**Addendum to Bid Documents**  
**Addenda No. 1**

**Invitation to Bid No. 2023-07**  
**Transformer Restock Purchase**

Contracting Agency:  
**The City of Raton**  
**Post Office Box 910**  
**224 Savage Avenue**  
**Raton, New Mexico 87740**

**POLES – Conventional (See Example Nameplate Below)**

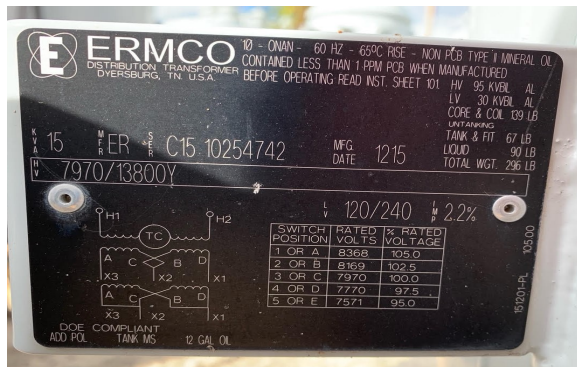
Q Verify the primary voltage and number of primary bushings – Is it 7970/13800Y with 2 primary bushings?

Q Verify the TAPS on poles. Does that mean split taps? Or Taps Above OR Taps Below?

Q Is there an IFD?

R Yes, that is correct. 7970/13800Y with 2 primary bushings.

R We use split taps, 2 up, 2 down, 1 center.

R Not necessary.

**Single Phase Pads – Deadfront, Loopfeed, (See Example Nameplate Below)**

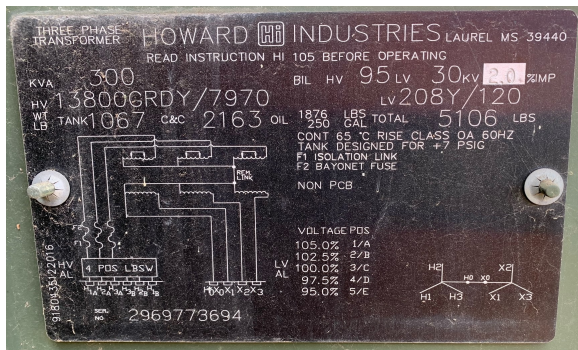
Q Verify the primary voltage. Usually padmounts are grounded wye primaries. Do they want 13800grdy/7970?

Q Verify the secondary voltage. 120/240 means 4 low voltage bushings. 240/120 means 3 lvb's and is standard. – Which do they want?

Q Wells Only, Not wells and inserts?

Q Bayonet-isolation link fuse or current limiting fuse?

Q Stud or Spade Secondary?

R Yes, that is correct. 13800grdy/7970

R Standard, 240/120 with 3 lvb's.

R \*Wells and inserts\*

R Bayonet isolation link fuse.

R We normally add our own spades, but it's ok if transformer has them included.
